PRODUCT CHANGE NOTIFICATION

Optimization of Frame

Module Series Affected: YLxxxC-30b, YLxxxD-30b, YLxxxC-36b ,
YLxxxD-36b

June 6th, 2017 // PC17001B

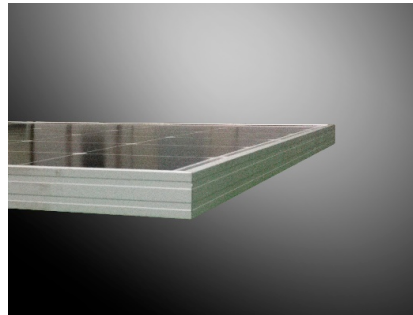
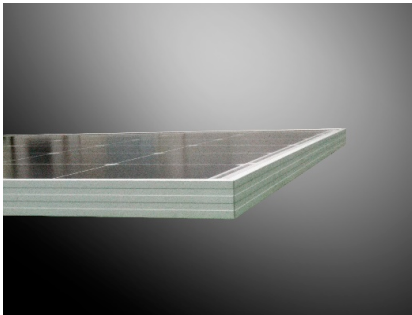
Yingli Solar is introducing modules with two optimized frames.

I . Applied to YLxxxC-30b and YLxxxD-30b series products: According to the internal cavity structure optimized, the thickness of the side surface of the frame will be changed from 40mm to 35mm, the length of upper limb and lower limb of the frame will be changed from 12mm, 32mm to 10mm, 35mm. The optimized modules keep the excellent mechanical performance, the reliability of stability and also the characteristics of lightweight.

II . Applied to YLxxxC-36b and YLxxxD-36b series products: According to the internal cavity structure optimized, the length of upper limb and lower limb of the frame will be changed from 12mm, 32mm to 10mm, 35mm. The optimized modules keep the excellent mechanical performance and the reliability of stability. There has nothing changed with the electrical properties.
